WATERFORD - UNIT 3

9408160161 940811
PDR ADDOCK 05000382
PDR

1.9a The CORE OPERATING LIMITS REPORT is the Waterford 3 specific document that provides core operating limits for the current operating reload cycle. These cycle-specific core operating limits shall be determined for each reload cycle in accordance with Technical Specification 6.9.1.11. Plant operation within these operating limits is addressed in individual specifications.

Figure 3.1-0

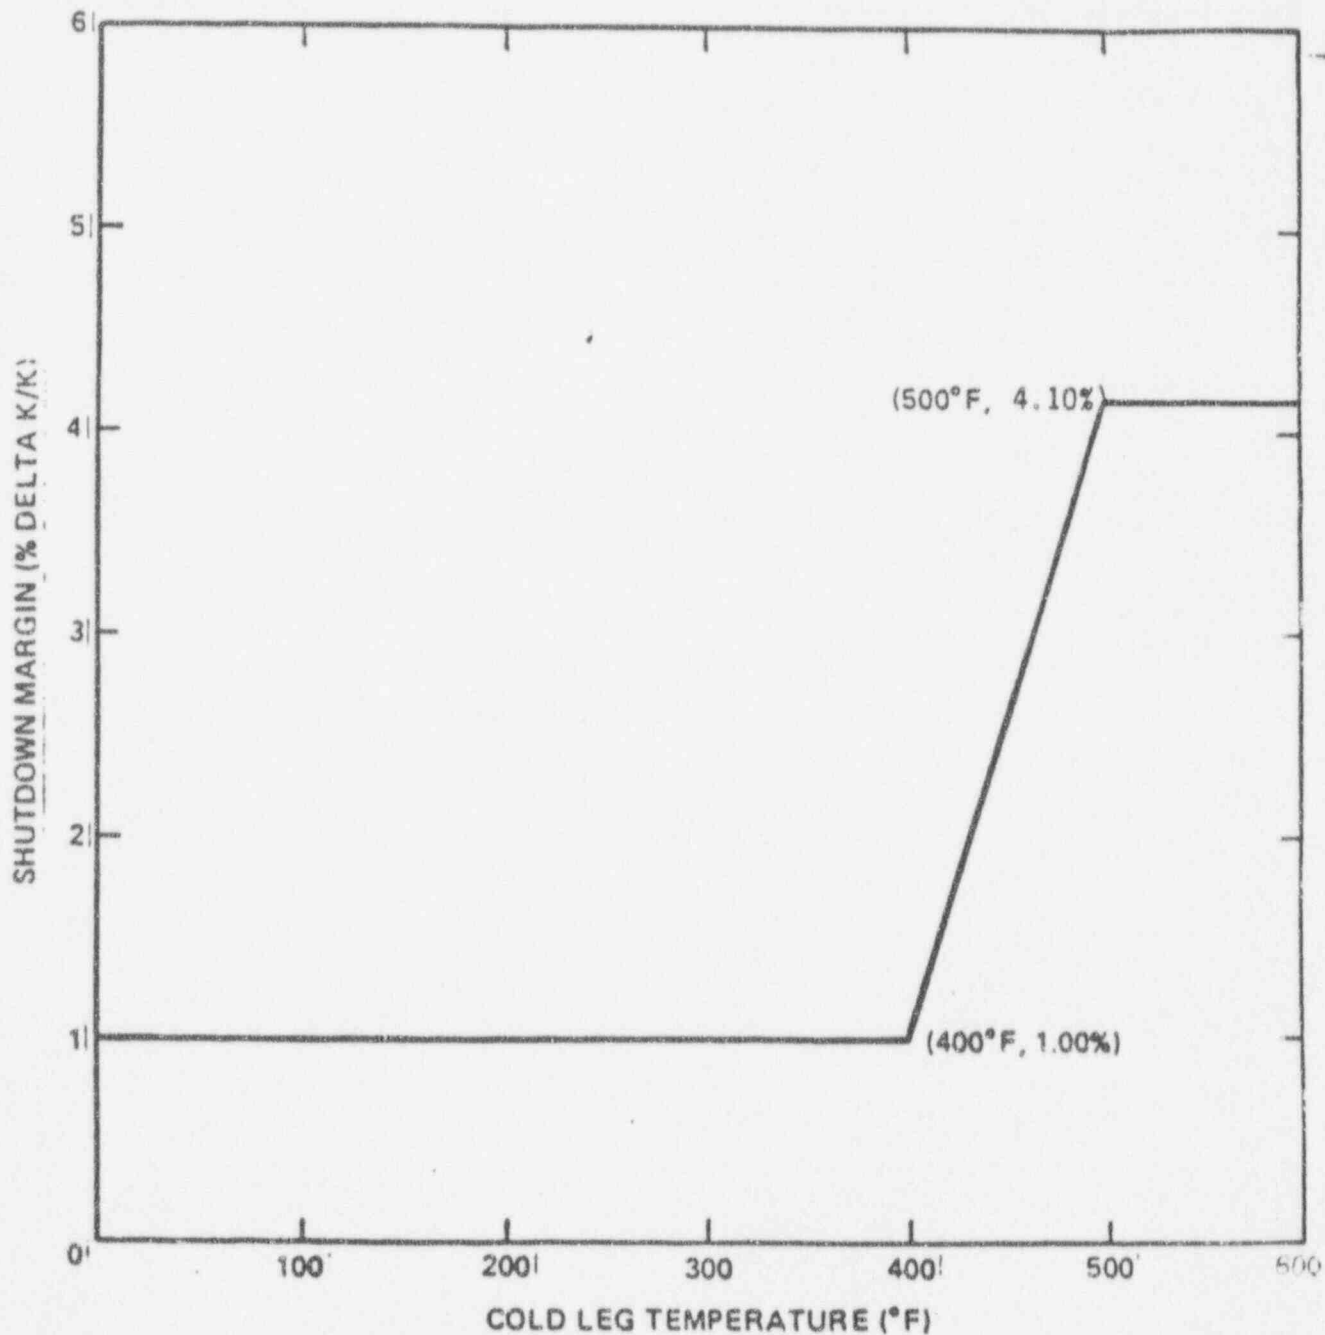
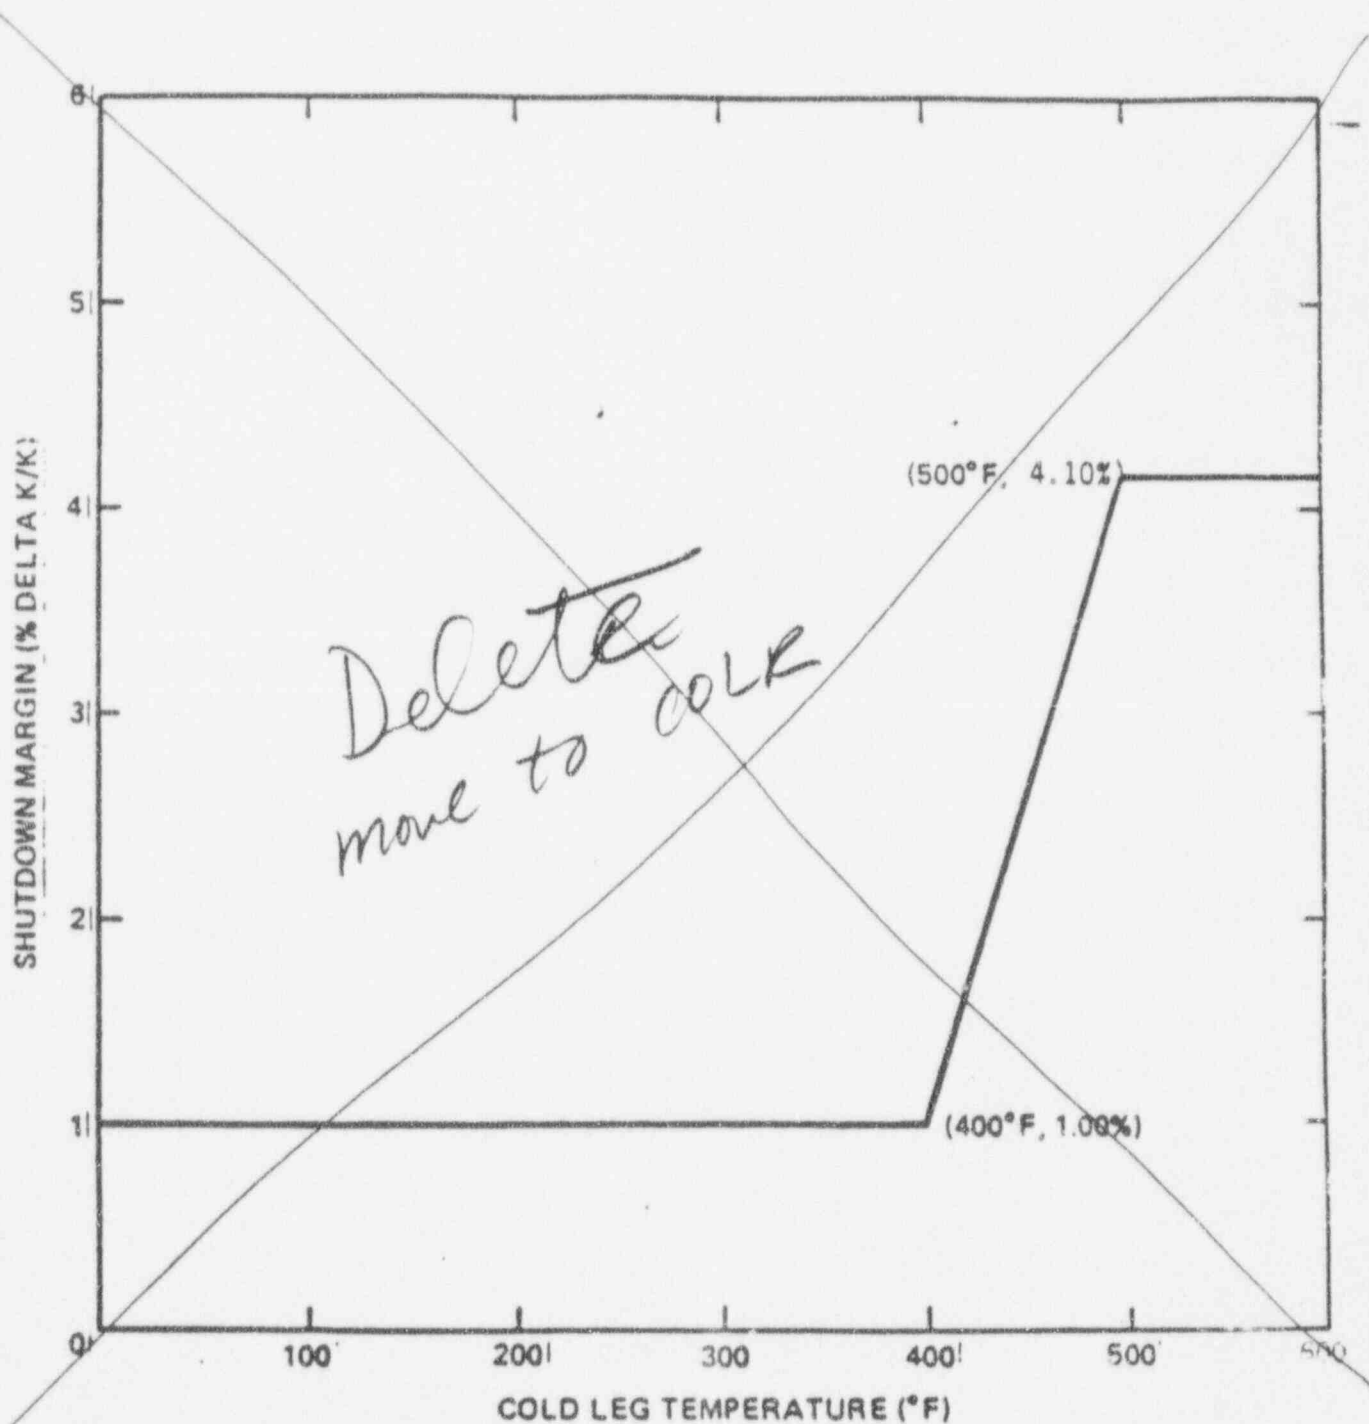
3.1.1.2 The SHUTDOWN MARGIN shall be greater than or equal to that specified in the COLR, shown in Figure 3.1.0.

With the SHUTDOWN MARGIN less than that specified in the COLR shown in Figure 3.1.0., immediately initiate and continue boration at greater than or equal to 40 gpm of a solution containing greater than or equal to 1720 ppm boron or equivalent until the required SHUTDOWN MARGIN is restored.

FIGURE 3.1-2
CEA INSERTION LIMITS VS THERMAL POWER

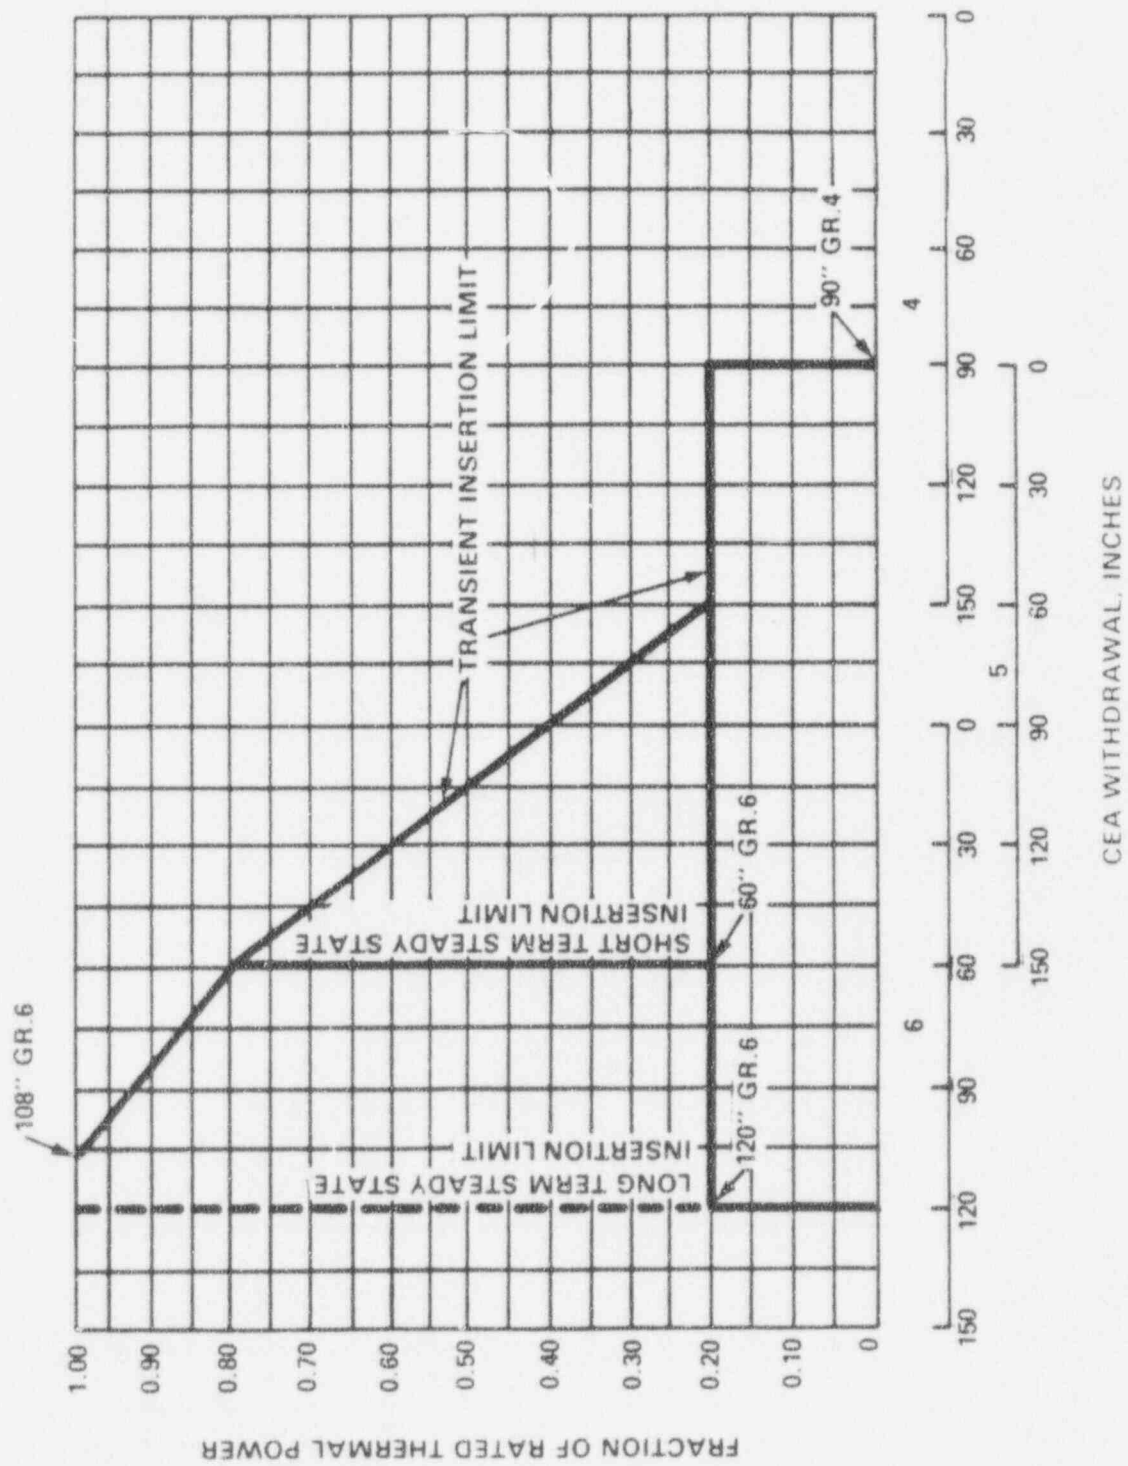
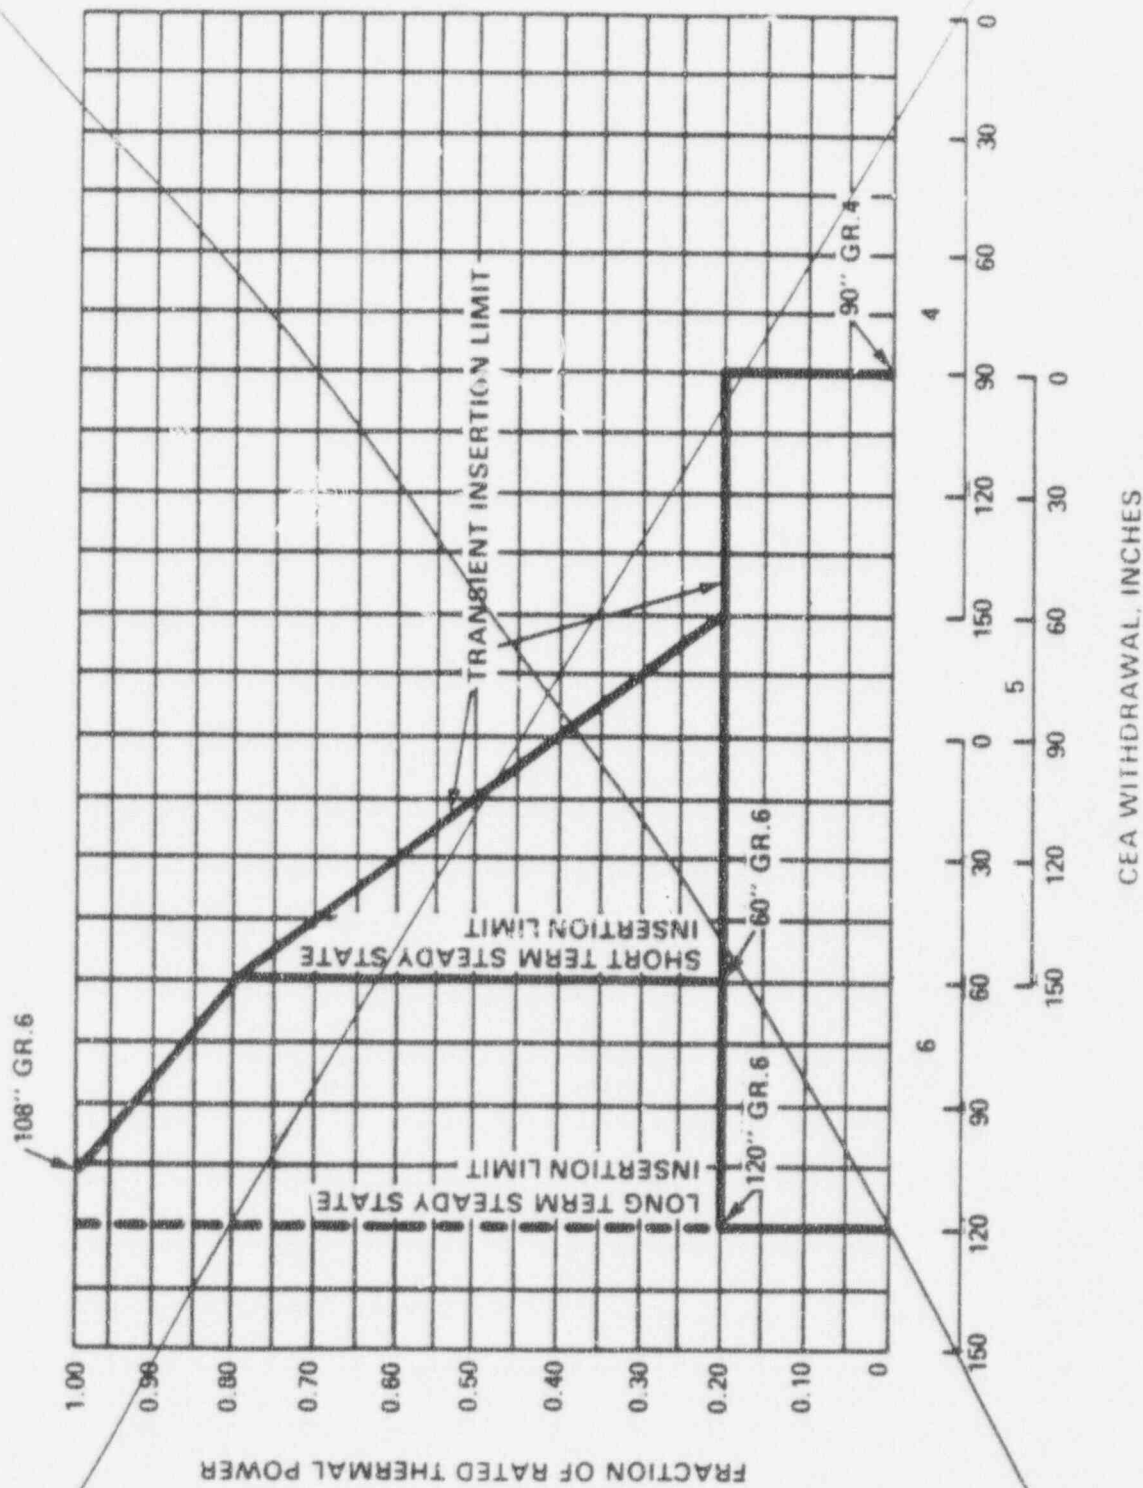
3.1.3.6 The regulating CEA groups shall be limited to the withdrawal sequence and to the insertion limits* specified in the COLR ~~**shown on Figure 3-1-2~~ with CEA insertion between the Long Term Steady State Insertion Limits and the Transient Insertion Limits restricted to:

*Following a reactor power cutback in which (1) Regulating Groups 5 and/or 6 are dropped or (2) Regulating Groups 5 and/or 6 are dropped and the remaining Regulating Groups (Groups 1, 2, 3, and 4) are sequentially inserted, the Transient Insertion Limit specified in the COLR ~~of Figure 3-1-2~~ can be exceeded for up to 2 hours.

**CEAs are fully withdrawn in accordance with the Transient Insertion Limit specified in the COLR ~~Figure 3-1-2~~ when withdrawn to at least 145 inches.

DELETE

THIS PAGE IS NOT USED

FIGURE 3.2-1
ALLOWABLE PEAK LINEAR HEAT RATE VS T_c

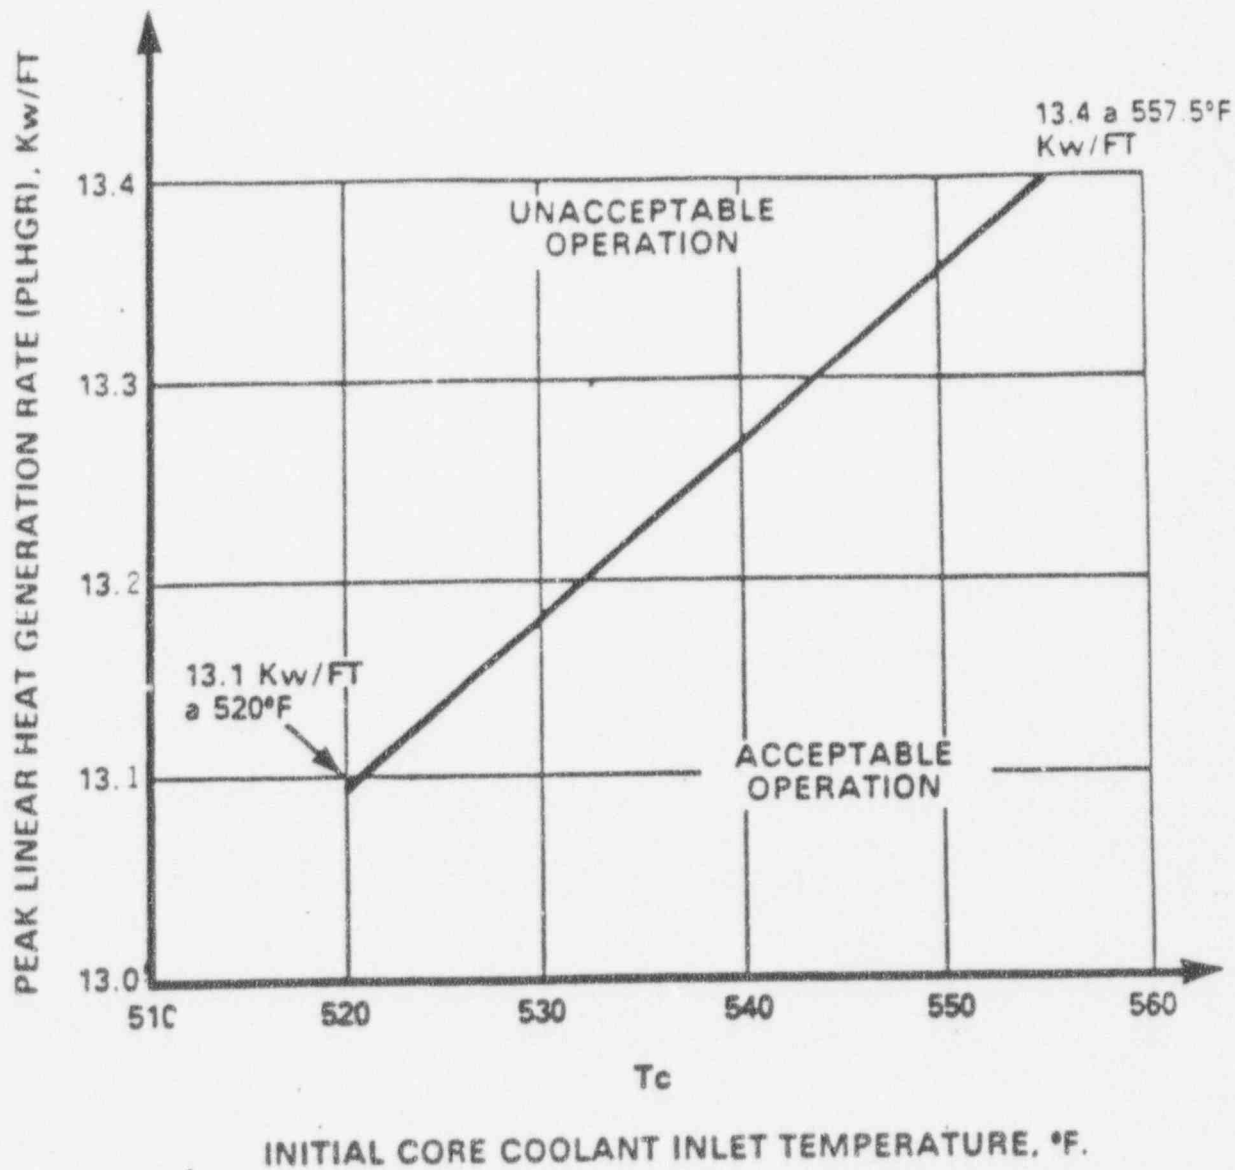
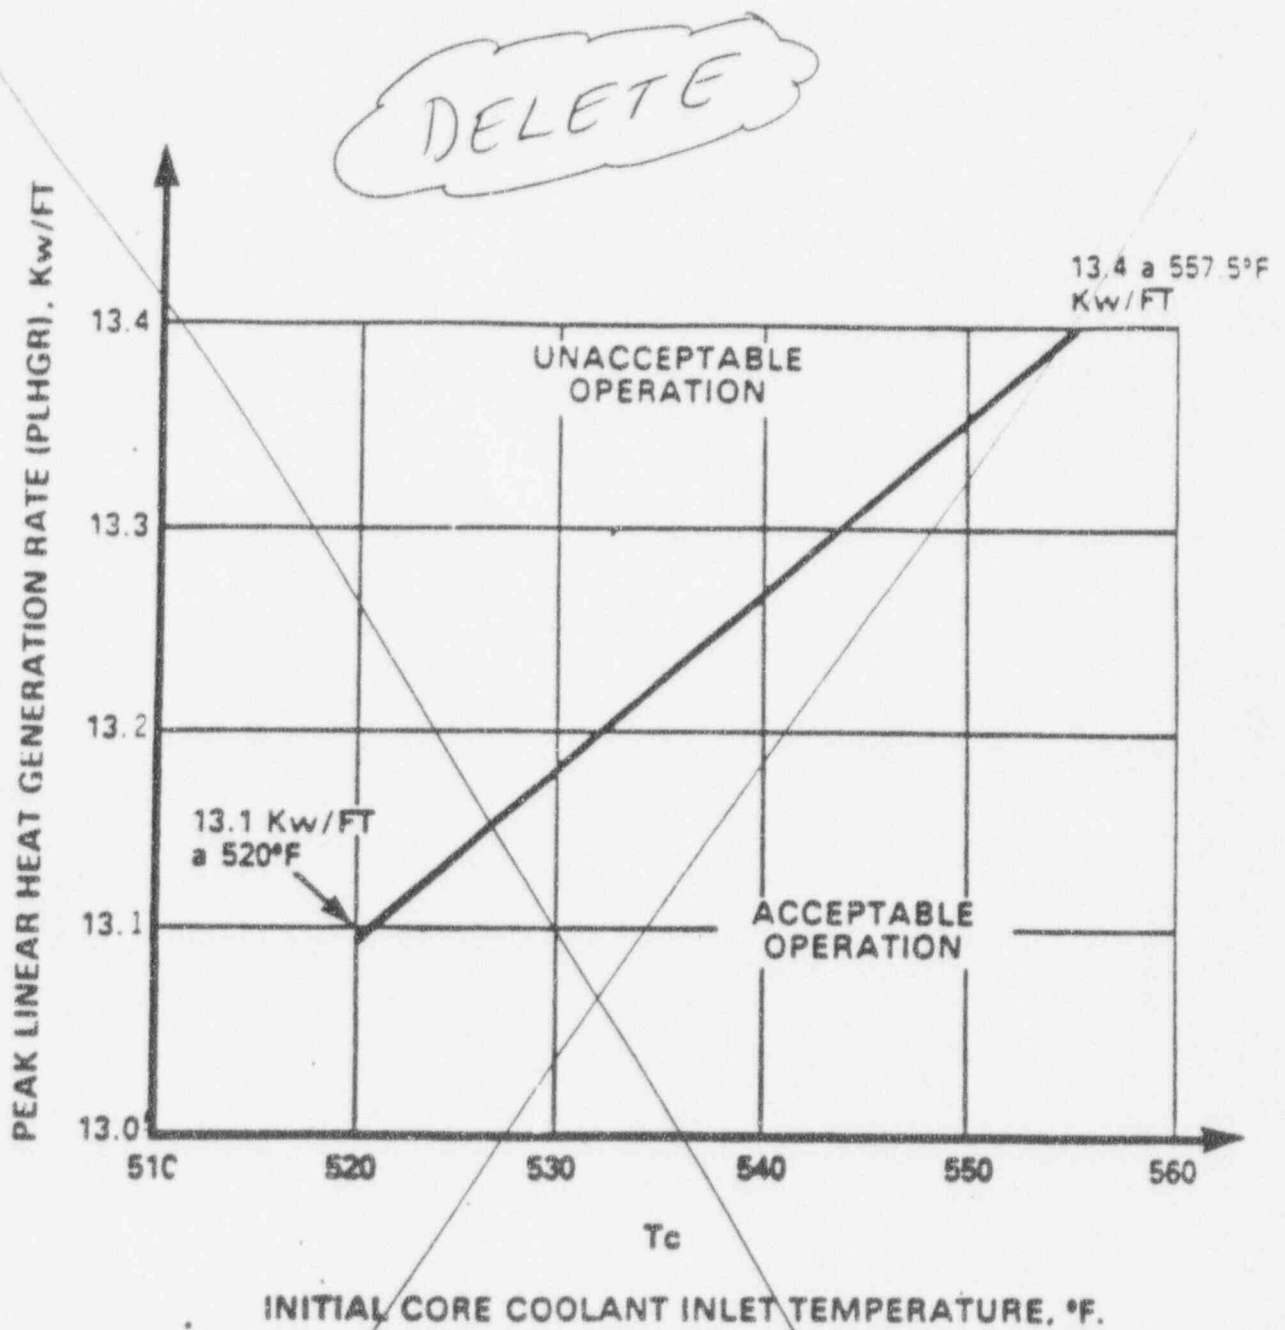
3.2.1 The linear heat rate limit, specified in the COLR, (~~of Figure 3.2-1~~) shall be maintained by one of the following methods as applicable:
